Access Compliance Report Public Rights-of-Way (Curb Ramps)

Main Street: CHARLOMA_DR		Cross Street: IRVINE_BLVD		Location:	SE
ADA ID: RPAT211027111742	Ramp Type: Type 3 - Combination 1	Initial Pass/Fail: Fail	Overall Compliance: No	Severity Score:	16
Codes/Mitigation Info/Possible Solution			Field Measurements/Component Compliance

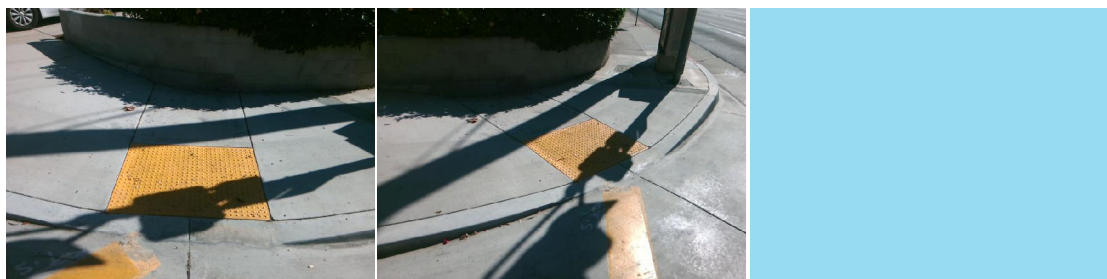
R304.2.2, R304.5.3, R304.3.2, STD 1115

Compliance	Description	Data	Compliance	Description	Data
N/A	Ramp Length LT (in)	77	N/A	Ramp Length RT (in)	45
Yes	Ramp Width LT (in)	75	Yes	Ramp Width RT (in)	58
No	Ramp Run Slope LT (%)	11.4	Yes	Ramp Run Slope RT (%)	2.5
Yes	Ramp Cross Slope LT (%)	0.6	Yes	Ramp Cross Slope RT (%)	0.4
N/A	Ramp Length (in)	45	N/A	Flare Type LT	
Yes	Ramp Width (in)	49			N/A
Yes	Ramp Run Slope (%)	6.8	N/A	Flare Slope LT (%)	N/A
No	Ramp Cross Slope (%)	3.5	N/A	Flare Traversable LT	N/A
N/A	Landing Present	N/A	N/A	Flare Type RT	
N/A	Landing Length (in)	N/A			N/A
N/A	Landing Width (in)	N/A	N/A	Flare Slope RT (%)	N/A
N/A	Landing Run Slope (%)	N/A	N/A	Flare Traversable RT	N/A
N/A	Landing Cross Slope (%)	N/A	N/A	DWS Provided	N/A
N/A	Landing Movement Obstructed?	N/A	N/A	DWS Contrast	N/A
	Landing Movement Type	N/A	N/A	DWS Length (in)	N/A
N/A	Landing Shared	N/A	N/A	DWS Full Width	N/A
N/A	Clear Space	N/A		DWS Offset Type	N/A
N/A	Clear Space To Crosswalk (in)	N/A	N/A	DWS Offset Left (in)	N/A

Remove & Replace Entire Ramp.
